REMARKS/ARGUMENTS

Application No.: 09/598,372 Amendment dated March 25, 2004

Reply to Office Action dated January 26, 2004

Figure 7

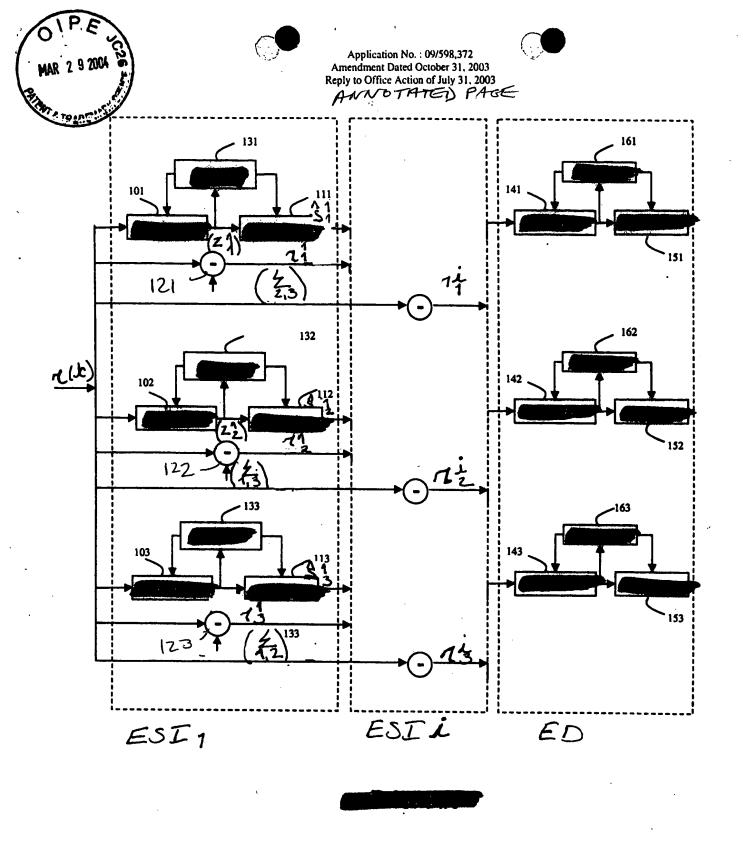
FIGS. 6 and 7 have been corrected to include reference numerals 121, 122, and 123, which were inadvertently omitted from the corrections previously submitted.

Figure 8

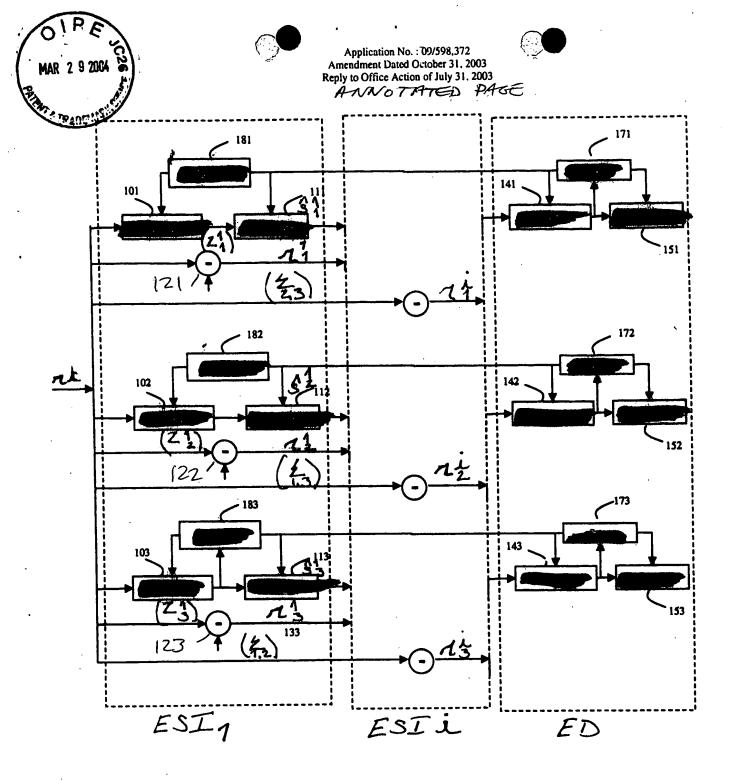
with the written description and drawings. Specifically, with reference to FIG. 8, element 171 (or 172, or 173), which is described as a synchronization means (specification, page 11, lines 9-10), is depicted as providing control signals to the interference suppression means ESI_i, ESI₁ (specification, page 11, lines 9-10) and to the decision means 151 (the leftmost arrow emanating from box 171 points to box 151, which is identified as the decision means on page 7, line 33—note that FIGS. 7 and 8 share some elements in common, as is commonly practiced, and as is clearly noted on page 11, lines 6-7, wherein it is stated that "Fig. 8 corresponds to fig. 7 and the same means carry the same references.").

Claim 1 further specifies, in a manner consistent with the remainder of the claim and the written specification and drawings, that "the means for producing the synchronization signals are constituted by K means solely placed in the K channels of the final stage (ED)," (FIG. 8 depicts the means 171, 172, 172 for producing the synchronization signals within the broken-line box labeled ED), and that "the K synchronization signals produced by said K means [control] the K decision means of the K channels of the final stage (ED) and the interference estimation means of the K channels of the at least one interference suppression stages (ESI_i) following appropriate time shifts." The K decision means are means 151, 152, 153, described as such for example on page 7, line 33 (again it is noted that that FIGS. 7 and 8 share some elements in common, as is commonly practiced). The interference estimation means of the K channels of the at least one interference suppression stages correspond to boxes 111, 112 and 113, described as such on page 11, line 17, for example. Time shifts are provided by circuits 181, 182 and 183. These relationships are clearly depicted in FIG. 8, showing appropriate arrows emanating from box 171 and pointing to box 151 in the final stage ED, and further pointing, by way of box 181, to box 111 in interference suppression stage box ESI₁. Based on the foregoing, it is urged that Claims
